ADDENDUM NO. 2

FY21 Stormwater Improvements
Project No. 21DPW12
Ayer DPW

LOCATION 2 - DOG PARK ROW BIOSWALE AND SIDEWALK CONNECTION

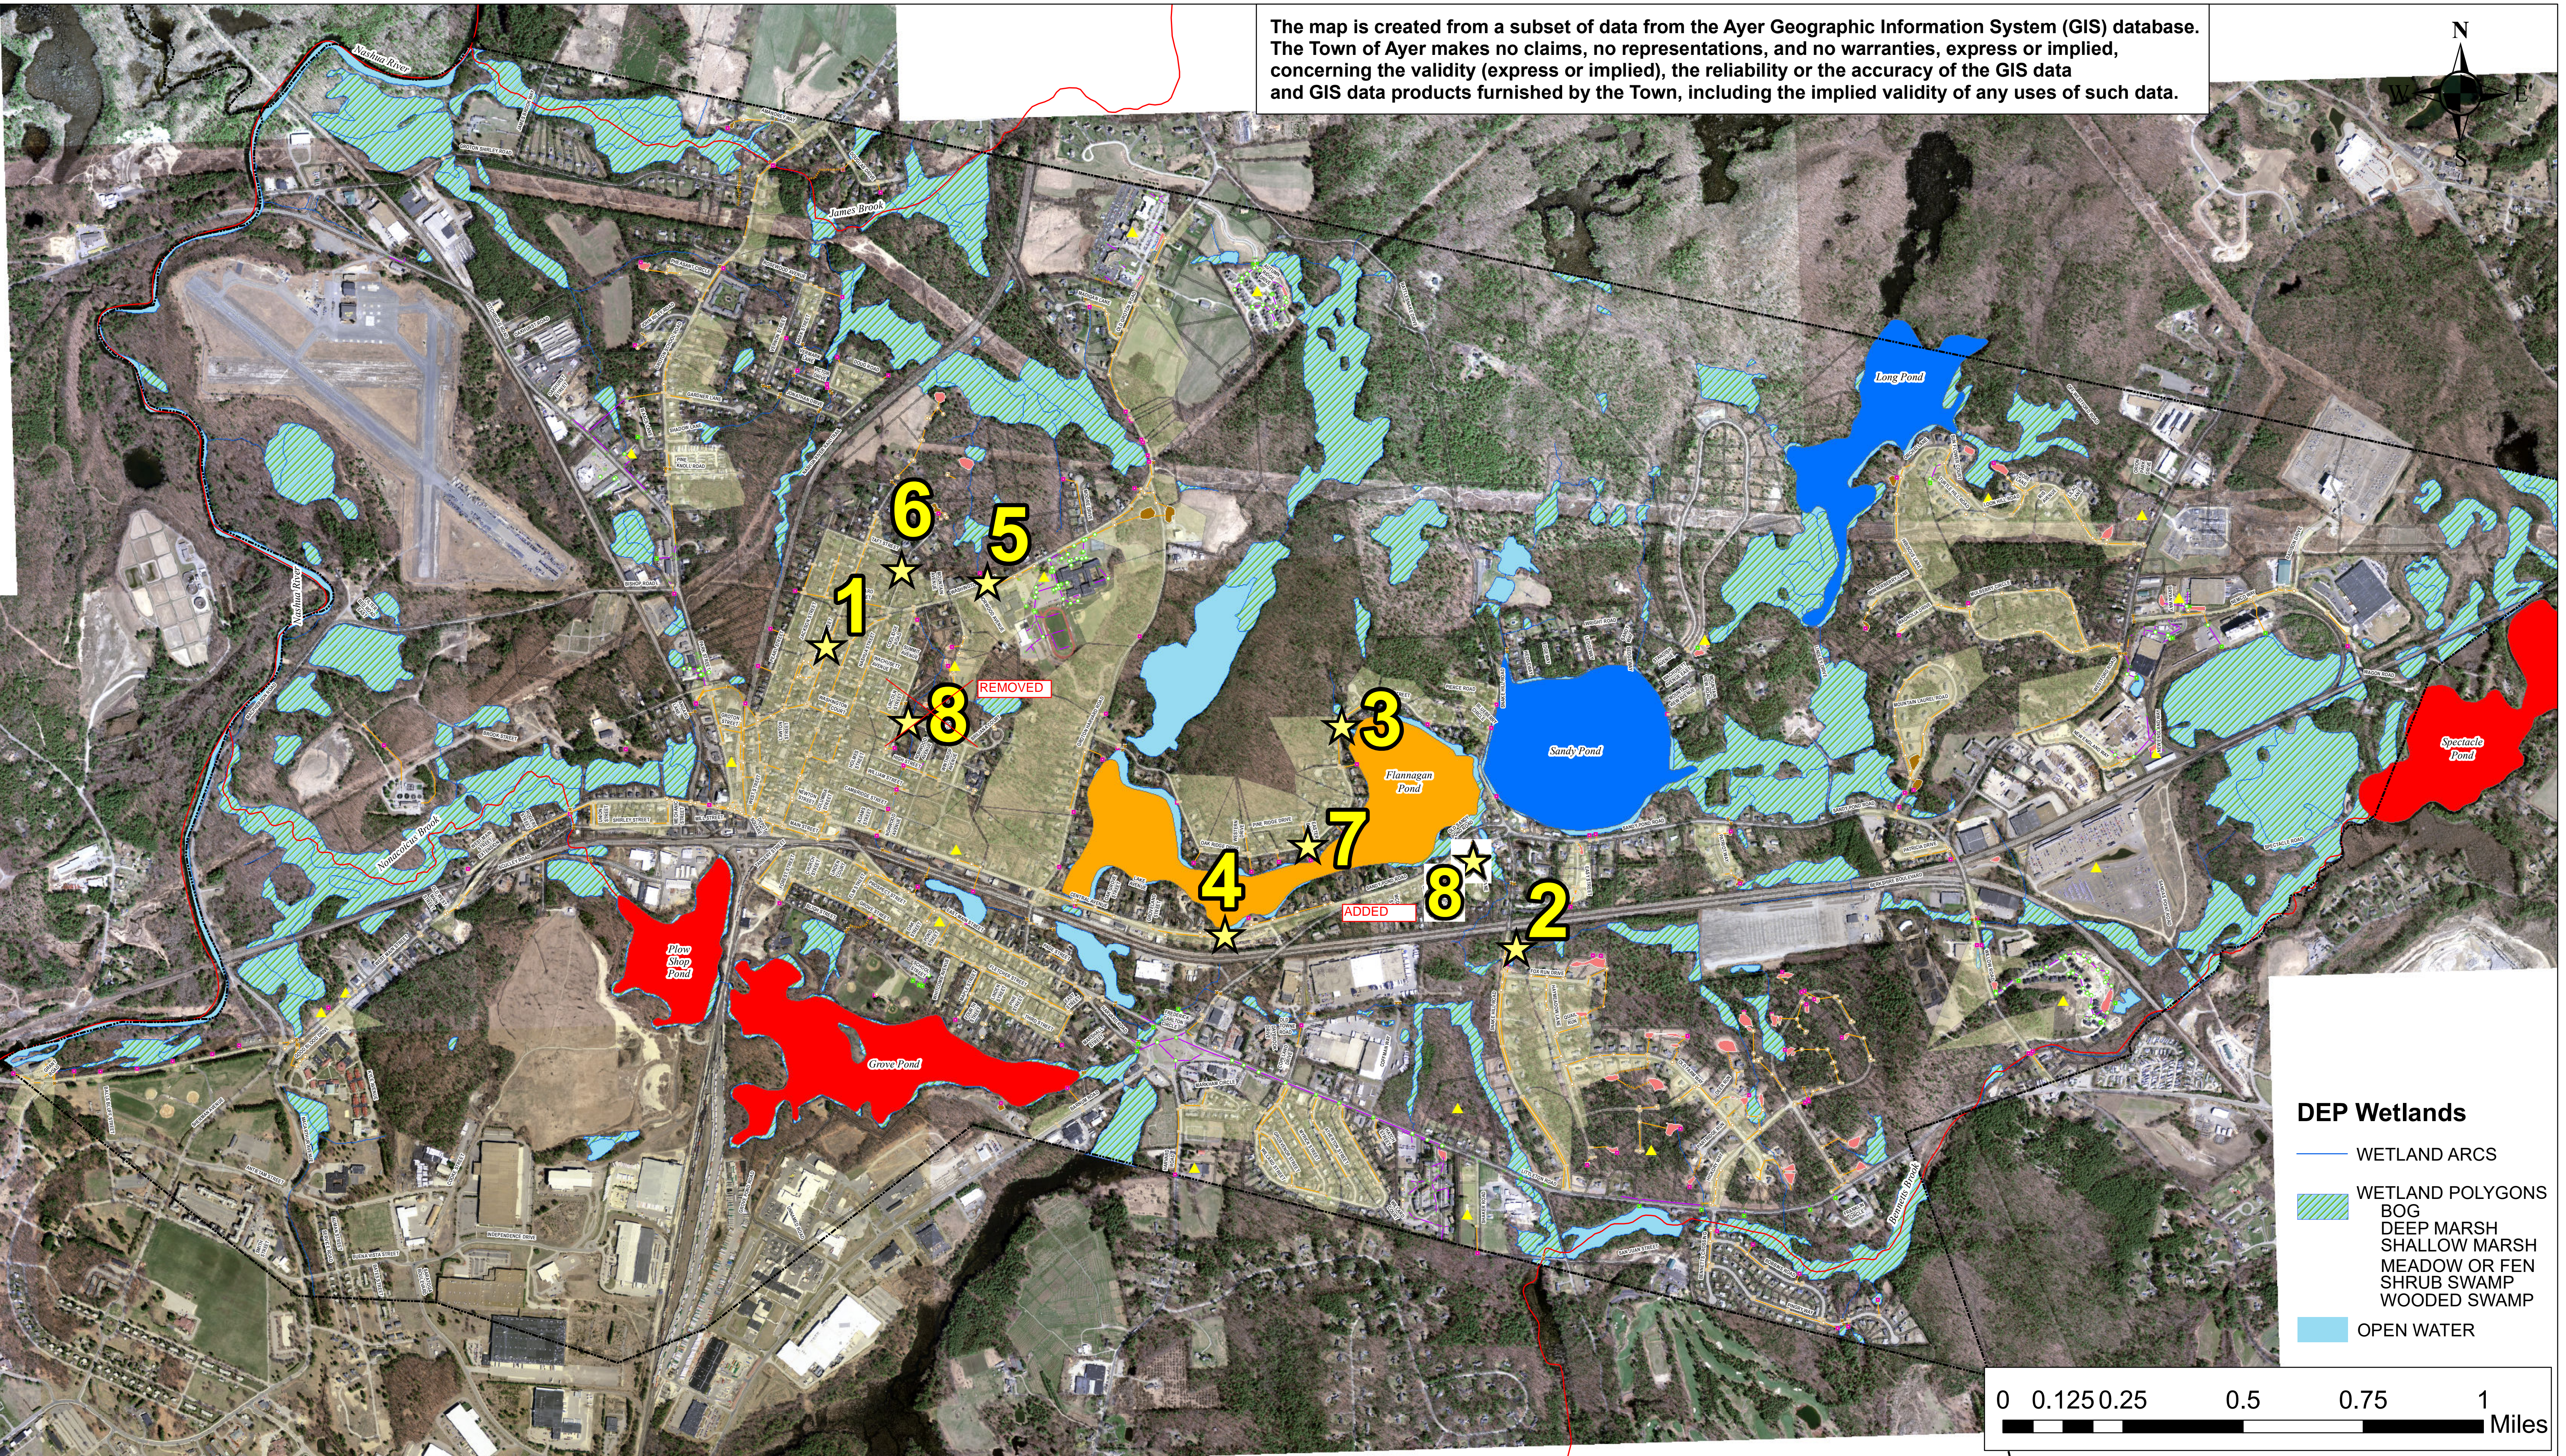
1. **REPLACE** FY21 STORMWATER IMPROVEMENTS OVERVIEW with the attached revised version. Location 8 has been changed from Highland Ave to Samantha Lane.
2. **REPLACE** LOCATION 2 – DOG PARK ROW BIOSWALE AND SIDEWALK CONNECTION with the attached revised version. The plan has been modified to include a fence.
3. **REMOVE** LOCATION 8 HIGHLAND AVE TREATMENT UNIT in its entirety. The work at this location has been removed from this project.
4. **INSERT** LOCATION 8 SAMANTHA LANE TREATMENT UNIT after LOCATION 7 BIORETENTION CELL 132 OAK RIDGE DRIVE. The Plan shows the installation of the stormwater treatment unit.

MARK	DATE	DESCRIPTION
A	4/23/21	ADD FENCE
